Subject: **Plan Modification: Clause 20A Amendment to the planning maps of the Auckland Unitary Plan (AUP) Operative in part (15 November 2016).**

<b>Rule or Section of Unitary Plan</b>	Auckland Unitary Plan, Planning Maps - National Grid Substation Corridor Overlay
<b>Subject Site (if applicable)</b>	24 Lincoln Park Avenue, Massey
<b>Legal Description (if applicable)</b>	Lot 3 DP 106455
<b>Nature of change</b>	<p>Amend the extent of the National Grid Substation Corridor Overlay (<b>Substation Corridor Overlay</b>) on 24 Lincoln Avenue Massey.</p> <p><b>Discussion</b> On 29 September 2020, Transpower advised council that the site boundary for its Henderson substation (Designation 8525) had changed.</p> <p>The National Grid Substation Corridor Overlay is a 12m buffer from the boundary of a substation (Chapter J, Auckland Unitary Plan).</p> <p>Therefore, as the site boundary for the Henderson substation had changed, the extent of the National Grid Substation overlay needs to be amended on the Auckland Unitary Plan, planning maps.</p>
<b>Effect of change</b>	<p>The National Grid Substation Corridor Overlay for 24 Lincoln Park Avenue, will need to be reduced in size. That is, much of

# Attachment 1: Updated GIS Viewer

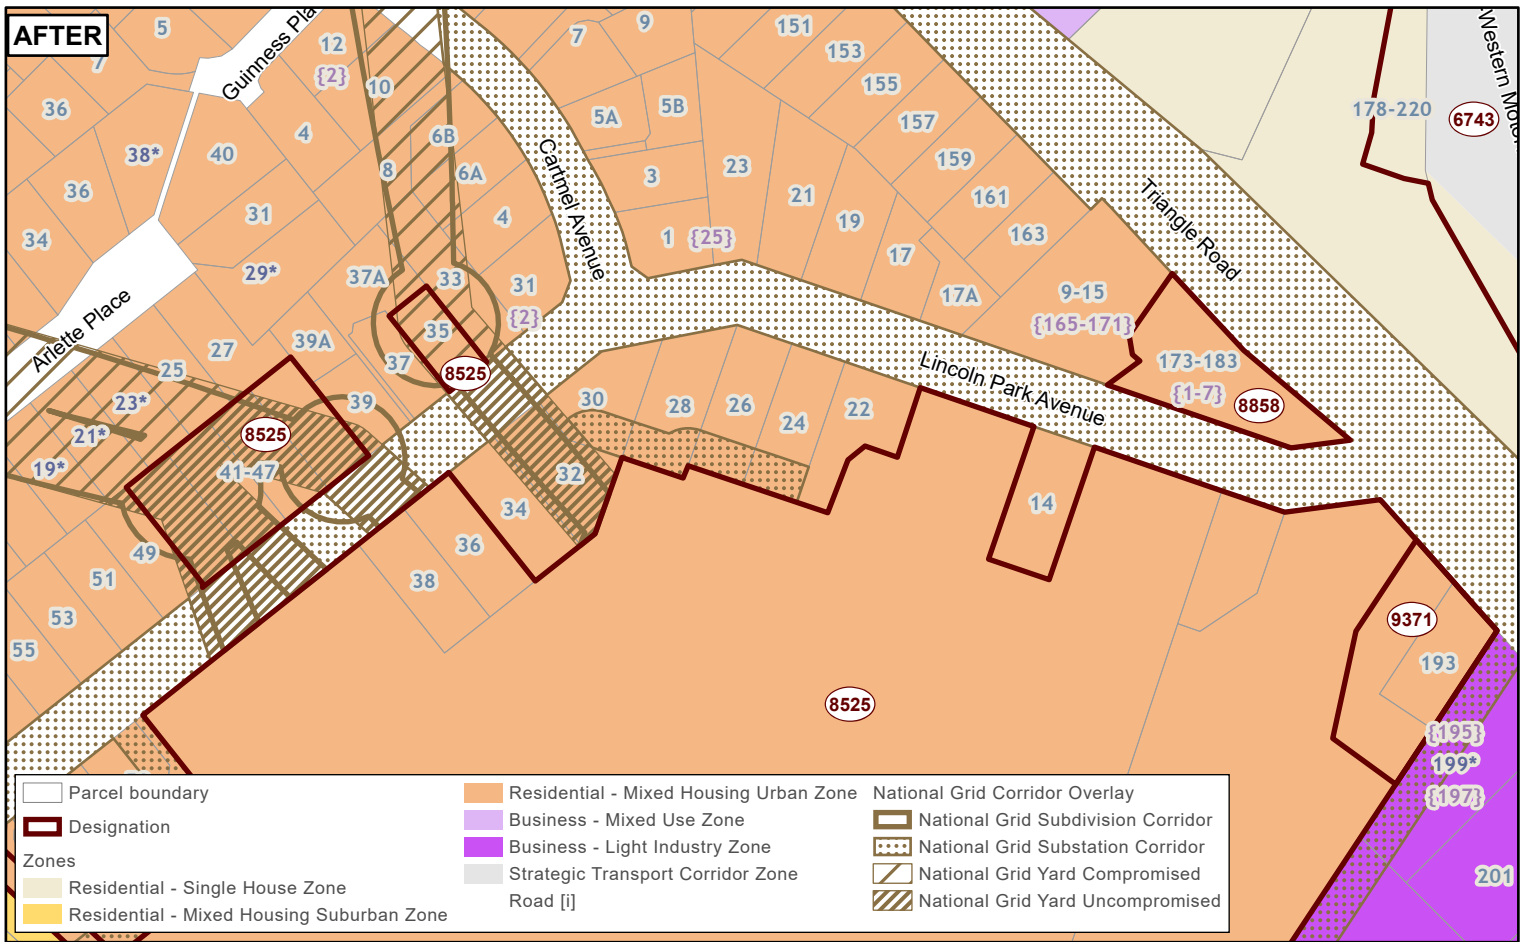
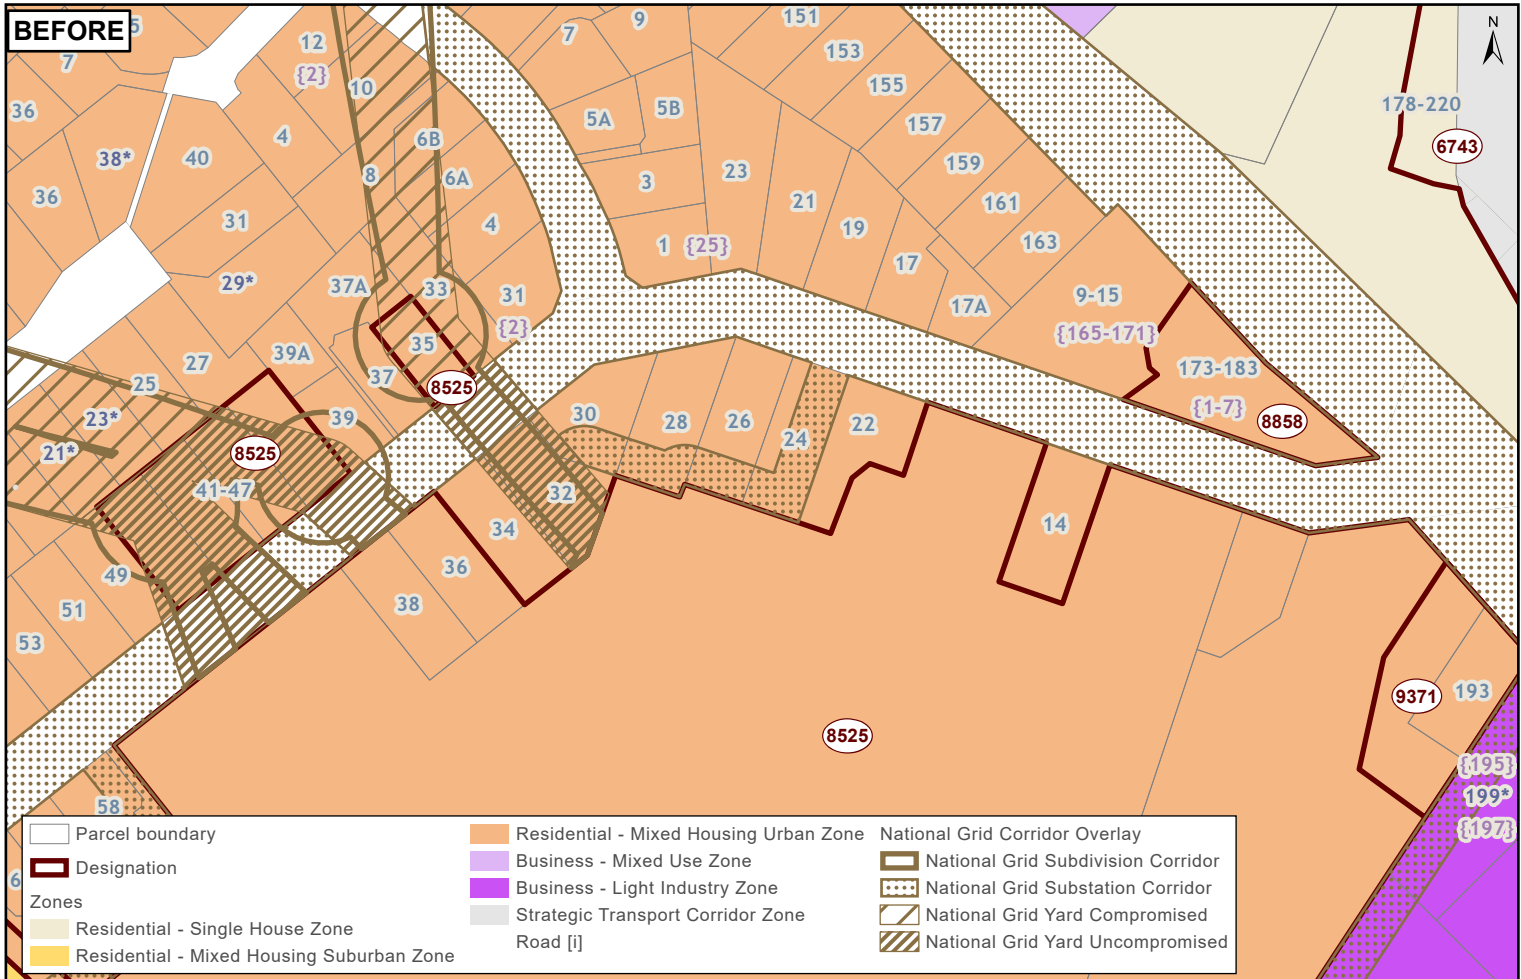
<p>According to Chapter D26 of the Auckland Unitary Plan, a National Grid Substation Corridor Overlay ceases to have an effect and the maps can be updated accordingly where:</p> <p>.... (b) a National Grid substation is dismantled, or the site boundary of a National Grid substation reduces in size and</p> <p>(c) Transpower New Zealand Limited has advised the Council in writing; and</p> <p>(d) The council has advised owners of the property from which the overlay will be removed in writing</p> <p>Transpower New Zealand Limited has advised council that the site boundary for this Henderson substation has changed, therefore satisfying Clause (b) and (c).</p> <p>The landowners contacted council enquiring about this overlay. While they have been advised by email, we will send a formal letter to advise the landowners about this change to the substation overlay over their property. This satisfies Clause (d). The landowners are in support of the amendment to this Substation Corridor Overlay to properly reflect its extent.</p> <p>Map 1 (attached) illustrates the changes required. .</p>

<b>Changes required to be made</b>	Amend National Grid Substation Corridor overlay on 24 Lincoln Park Avenue in the AUP planning maps, in accordance with Map 1 (attached)
<b>Attachments</b>	Attachment 1: Updated GIS Viewer
